CITY OF SMYRNA COMMUNITY DEVELOPMENT MEMORANDUM

RE: VARIANCE CASE V24-083
1565 Roswell Street – Reduce the front setback from 50 feet to 25 feet

VARIANCE CASE V24-084
1565 Roswell Street – Reduce the eastern side setback and landscape buffer from 10 feet to 9 feet

VARIANCE CASE V24-085
1565 Roswell Street – Reduce the required parking spaces from 49 spaces to 23 spaces

**Figure – 2
Site Plan**

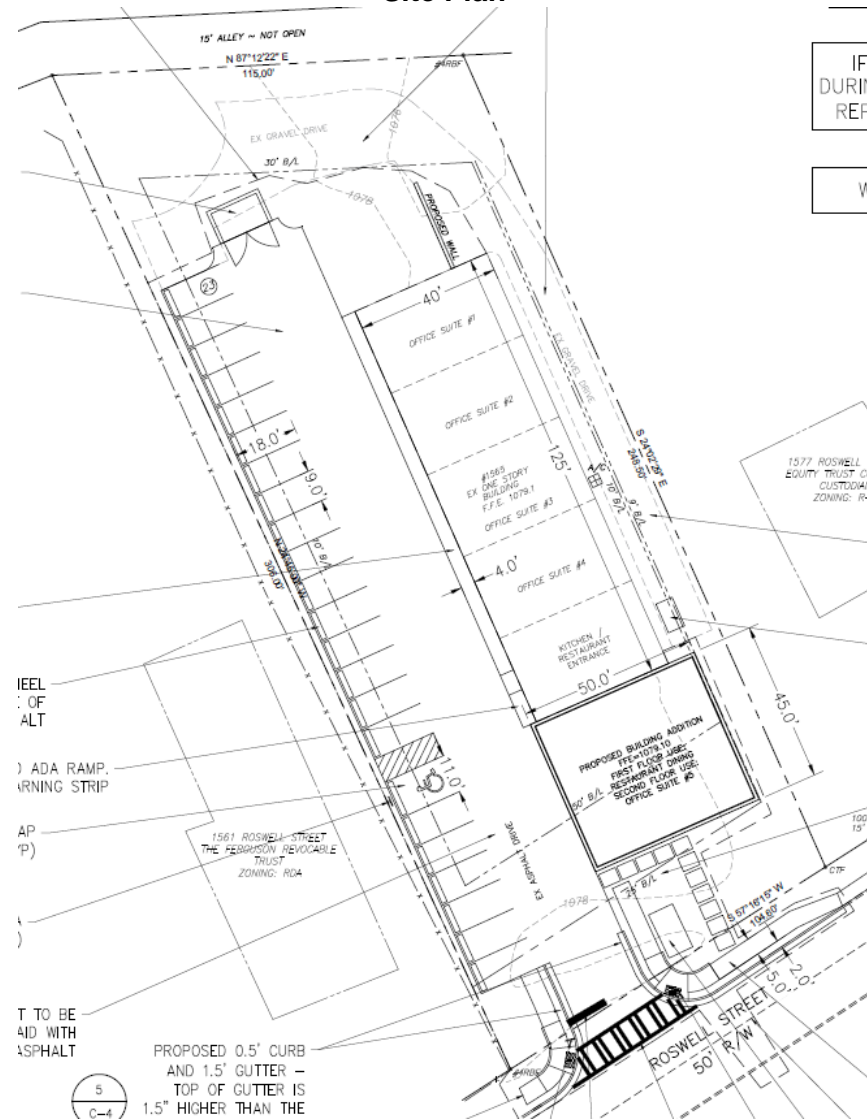
The existing building is located on the eastern side of the lot, with a mixed asphalt and gravel parking area on the front and western side of the property and wrapping around the building. Due to the configuration of the existing building and parking area on the site, the applicant can only provide 23 spaces while still maintaining the required 24-foot access aisle and parking space dimensions. Section 906.3 and Section 906.17 of the Zoning Ordinance requires 49 parking spaces on the subject property, which is calculated at 1 space per 250 square feet of gross floor area in the office areas and 1 space per 75 square feet of gross floor area in the restaurant space. Since the office spaces and restaurant are to cater to the surrounding neighborhood, the applicant is anticipating that the majority of clientele will be walking to the location. Thus, the need for on-site parking is limited.

In order to create a viable restaurant space, the applicant is requesting a variance to reduce the eastern side setback by 1 foot to maximize the amount of kitchen and seating potential within the restaurant. This encroachment will also cause the landscape buffer along the eastern side to be reduced to 9 feet nearest to the building. Section 503 requires a 10-foot landscape buffer along any sides of the property that abut residentially zoned properties. Since the property is within a residential neighborhood and has single-family detached homes on either side, the landscape buffer requirement is required. However, Section 503 was enacted in 1977, after the building was erected the year prior. Since the parking area has existed on the western side since the building's creation, no buffer shall be replaced in this location. Although there are homes at the rear of the property, an existing alleyway separates the commercial and residential zoning, so no landscape buffer is required. The eastern landscape buffer shall be installed to screen the two-story building from the new construction next door as dictated in Section 503 so there should be minimal impact to adjacent properties.

1. Approval of the requested variances shall be conditioned upon the development of the property in substantial compliance with the site plan and elevations submitted with the variance application.
2. A 9-foot landscape buffer shall be planted along the length of the eastern side property in accordance with Section 503. A fence shall not be used in place of the screening plants between the new addition and side property line but may be erected in combination with the screening plants.
3. There shall be a clear accessible route from the city sidewalk into the site as well as to and into each first-floor suite.
